DESIGN REVIEW COMMITTEE

September 21, 2022 6:00 PM

**DEPARTMENT OF PLANNING AND ZONING
PLANNER'S REPORT**

DATE: September 15, 2022
TO: Tonya Hutson
FROM: Lynn Patterson
RE: **Design Review – 3154 Lake Ave Window addition**

TITLE
PAGE
CODE INFO

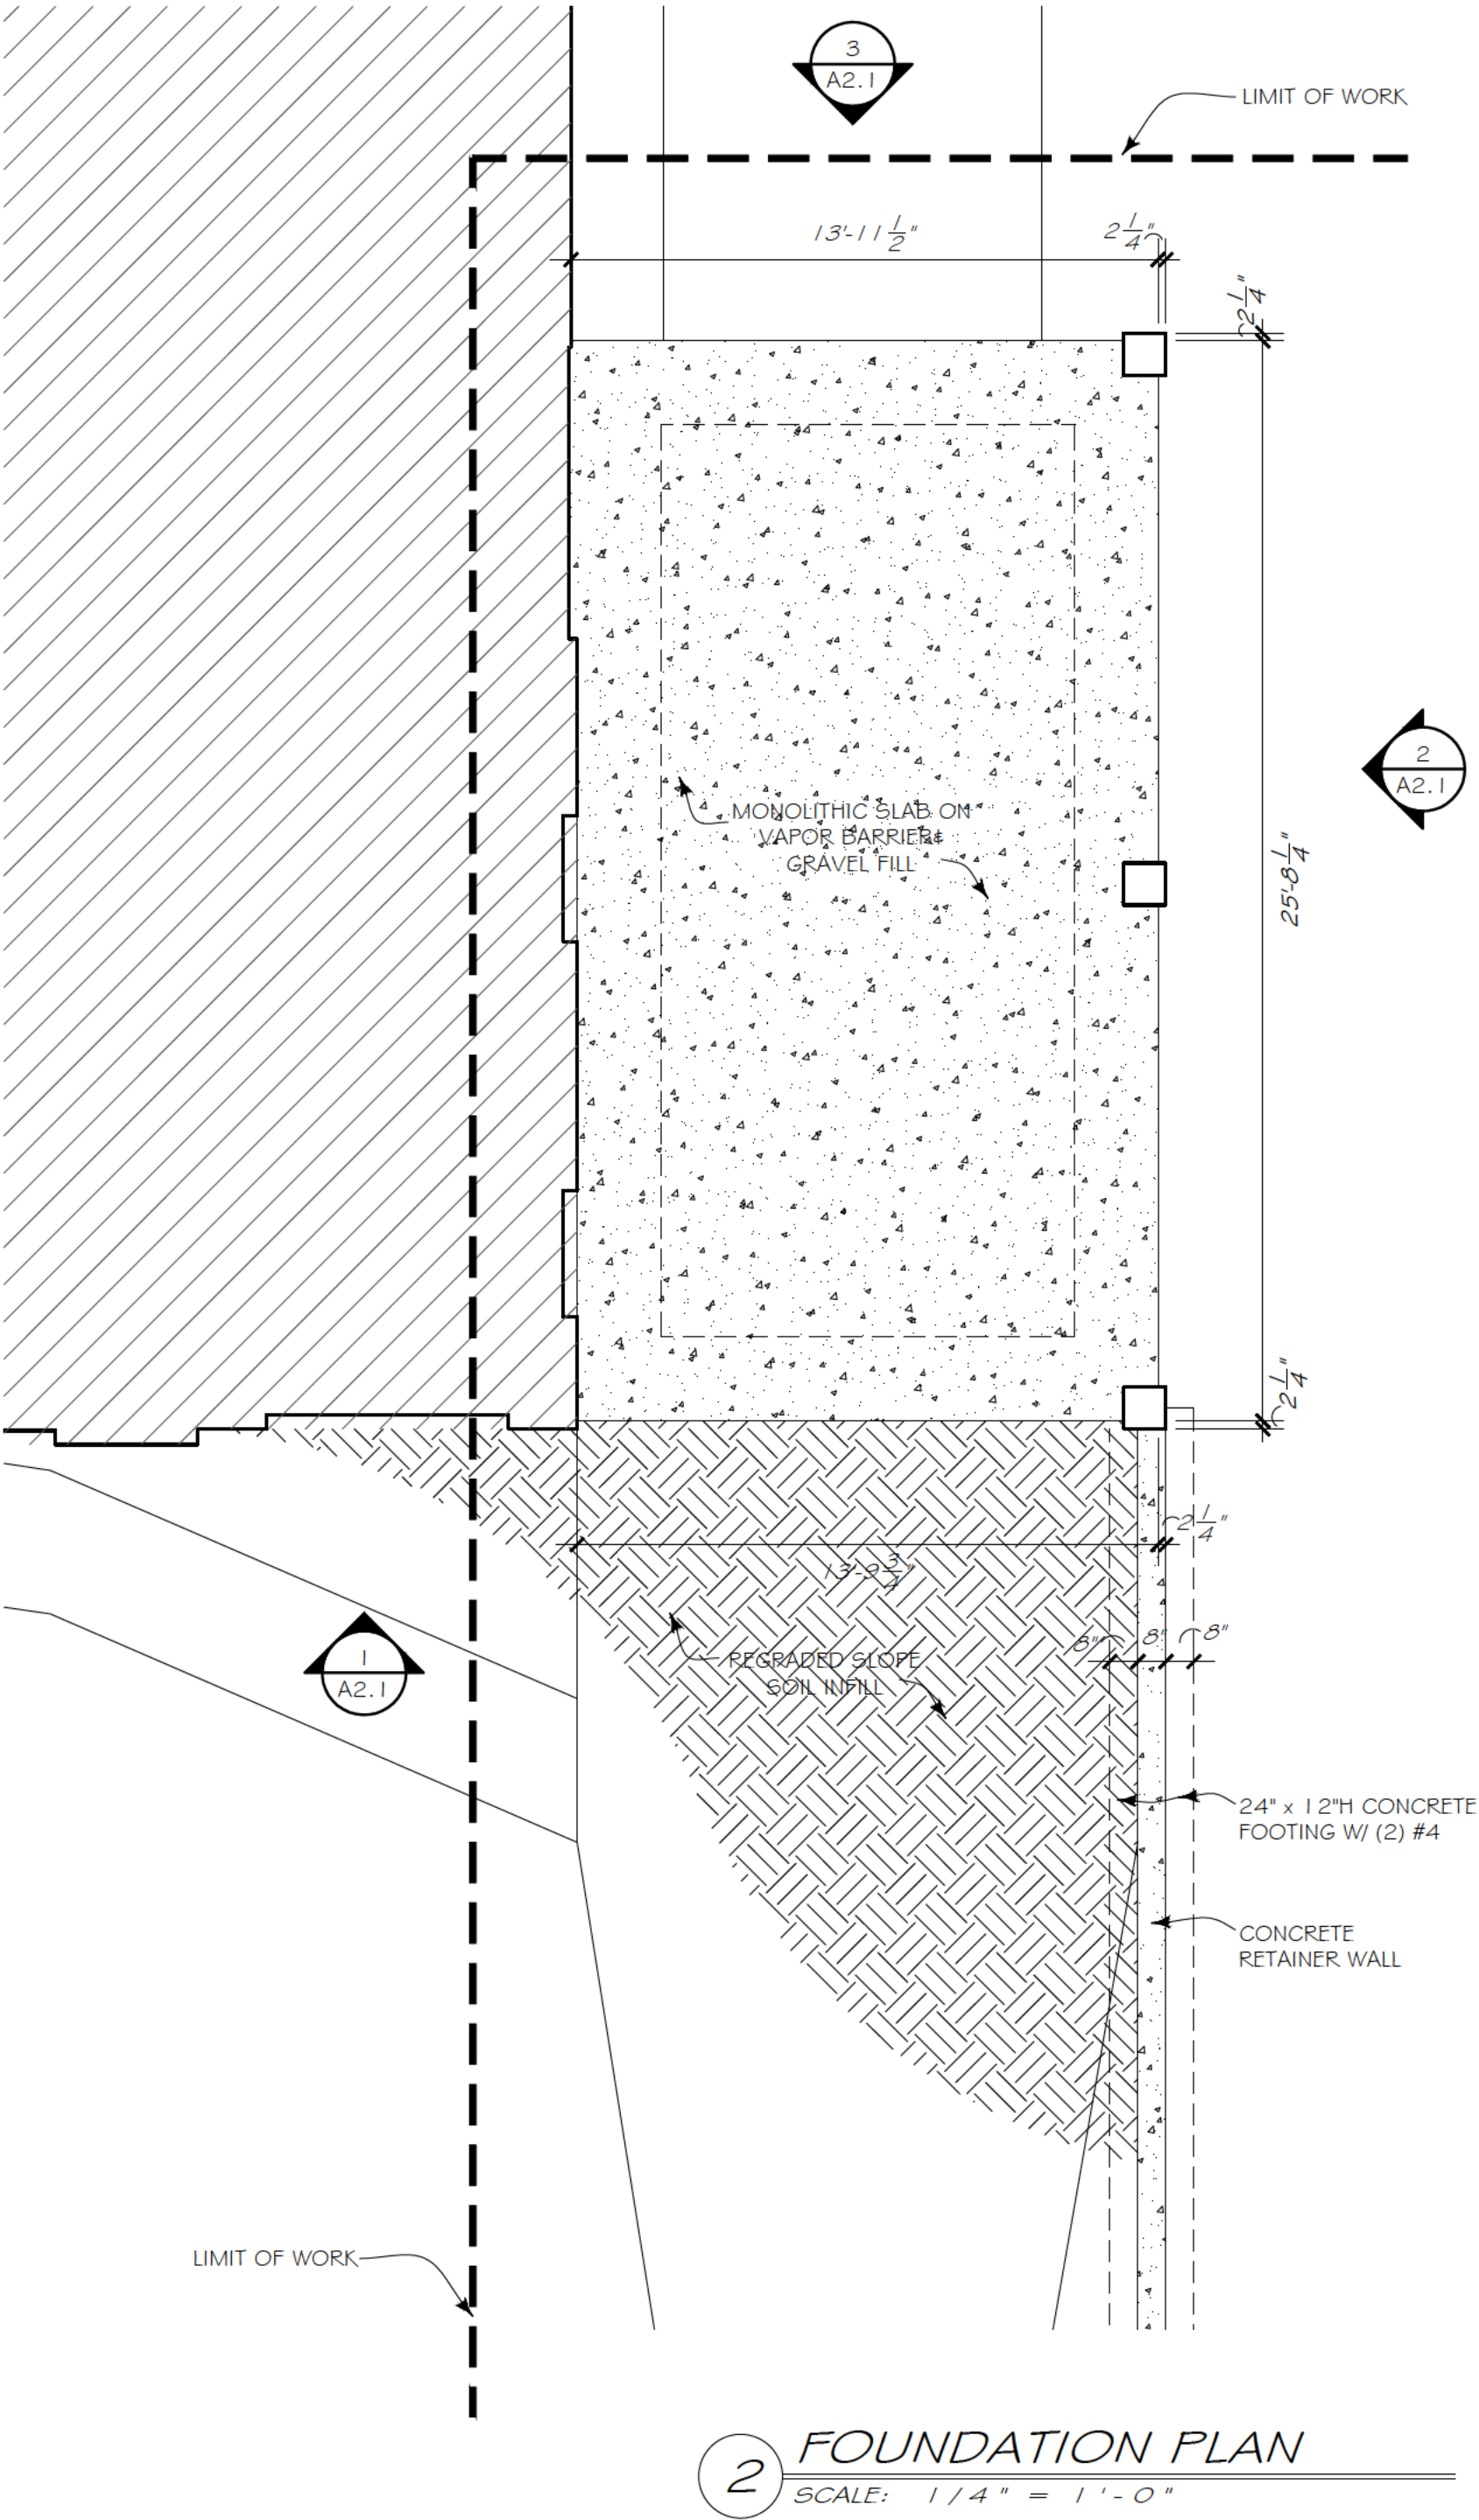
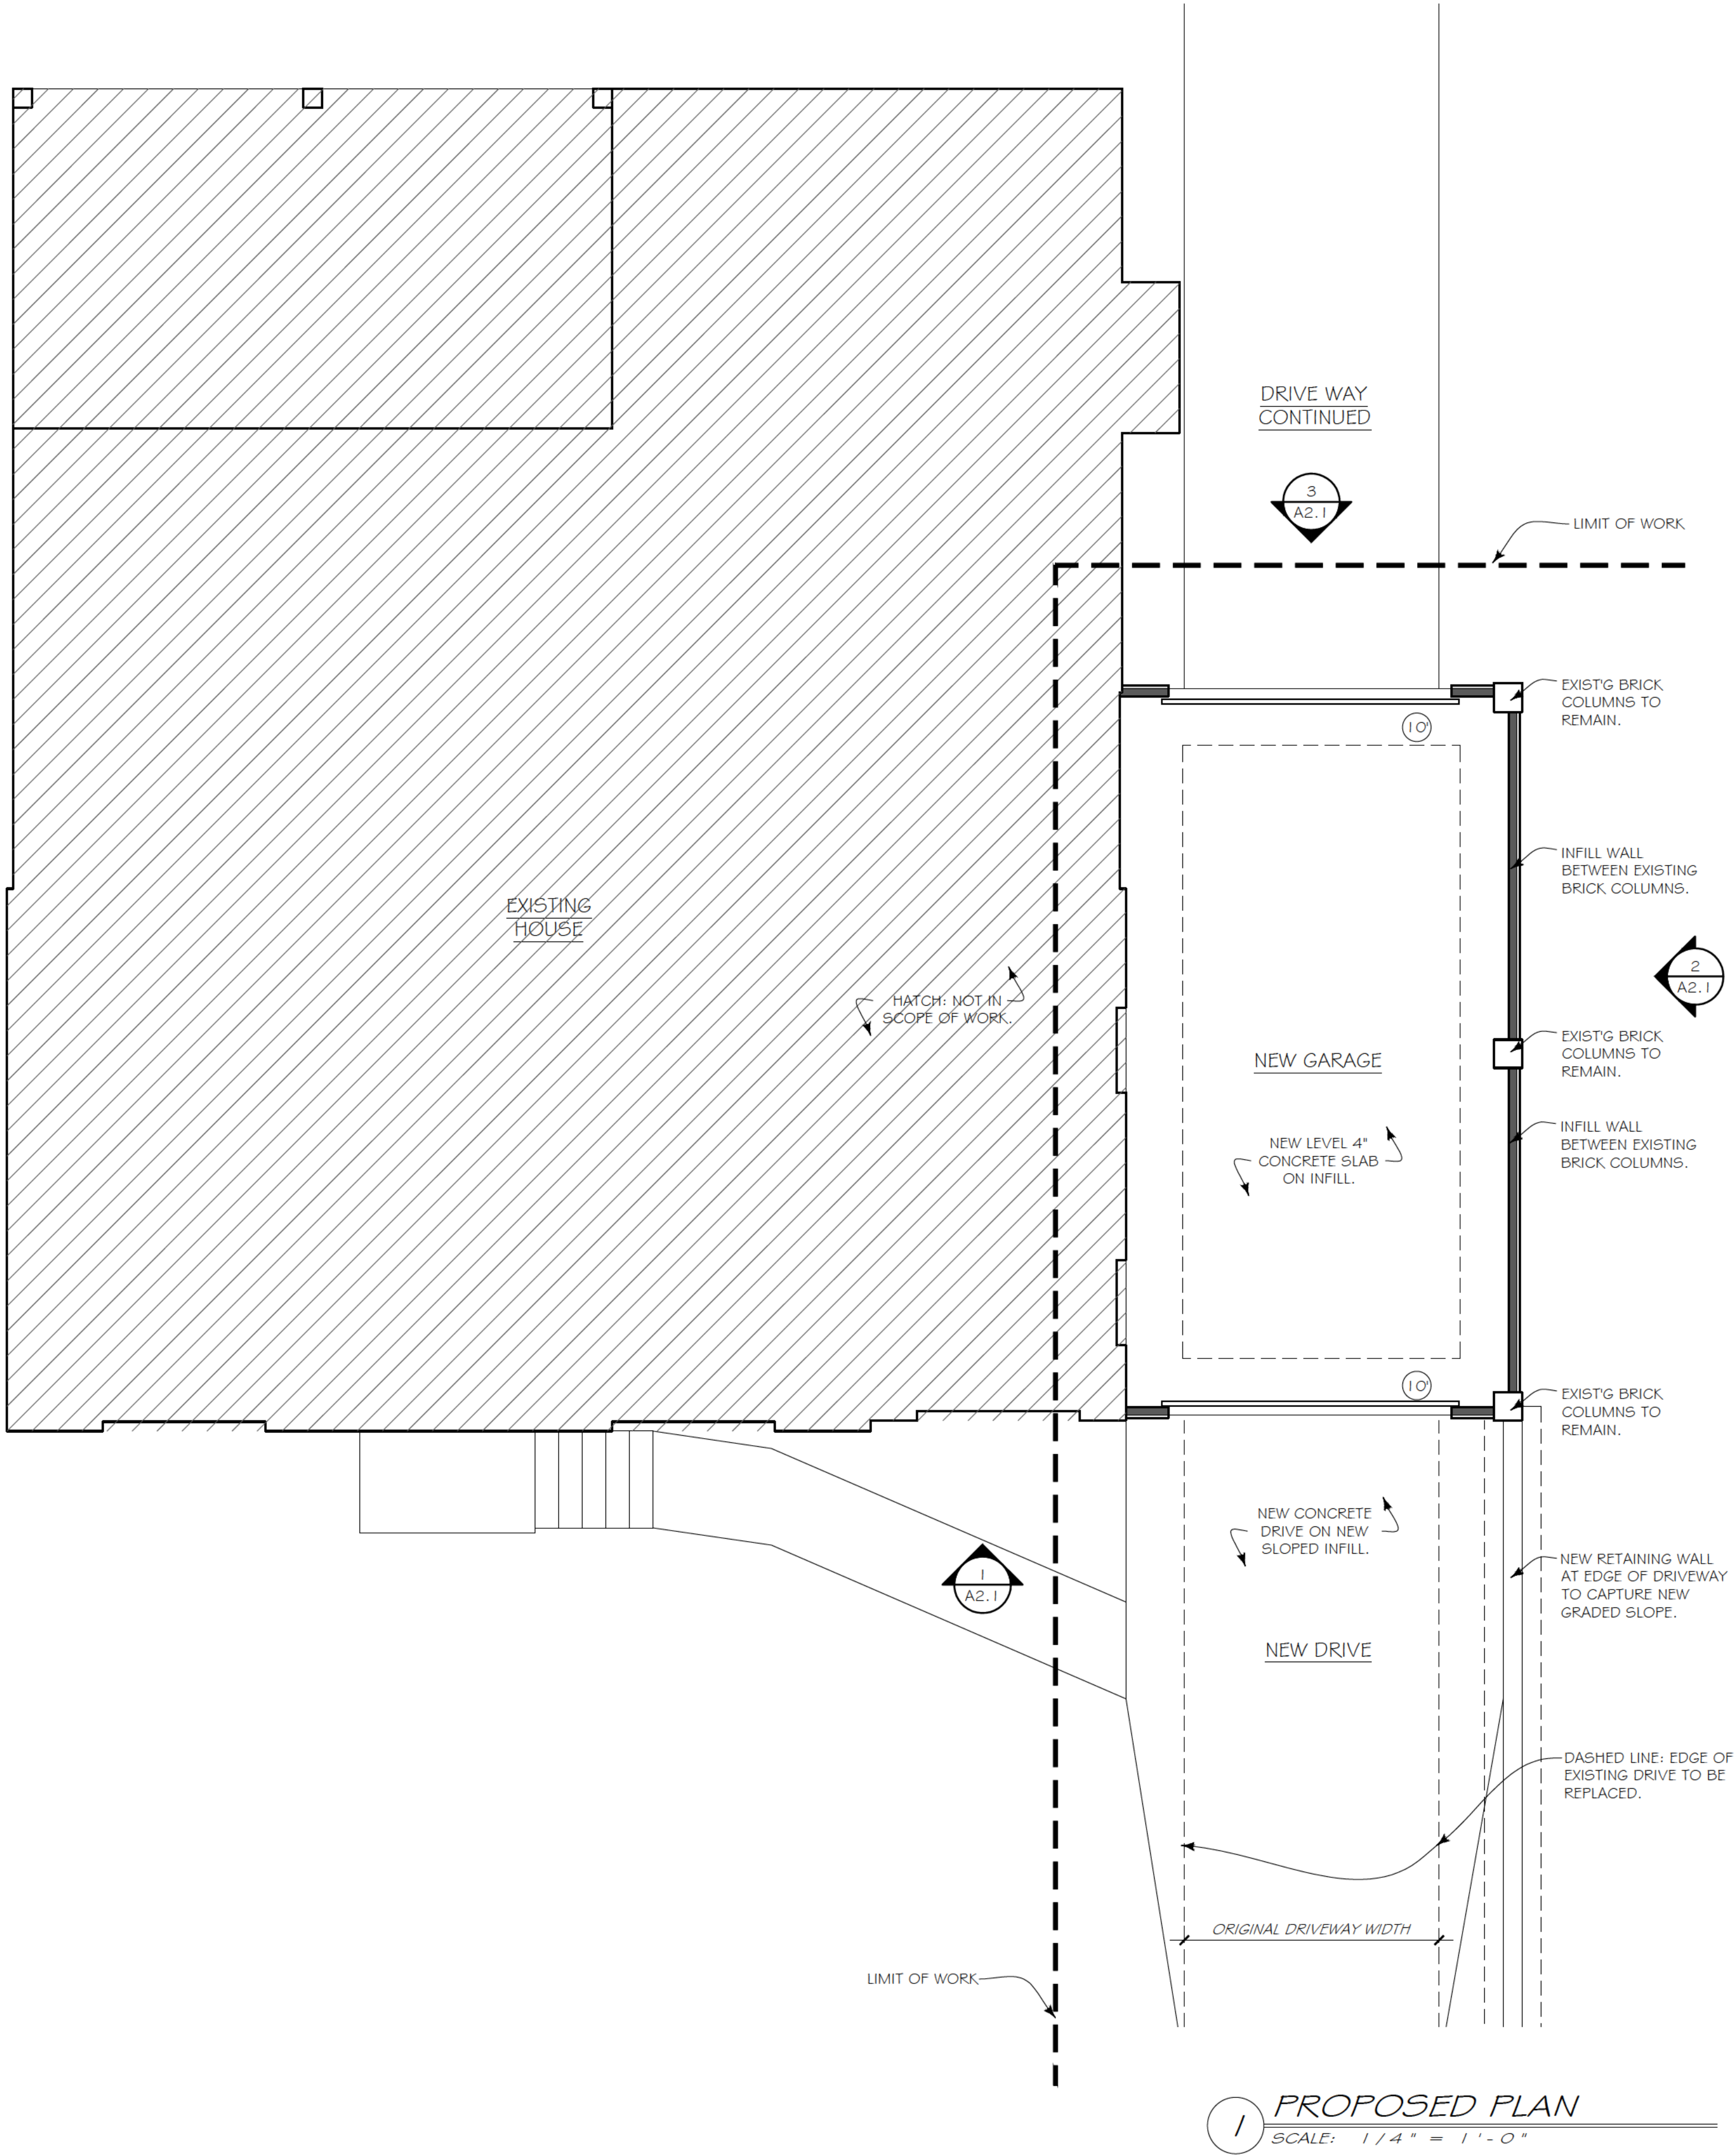
Note: The address should be corrected on the drawings.
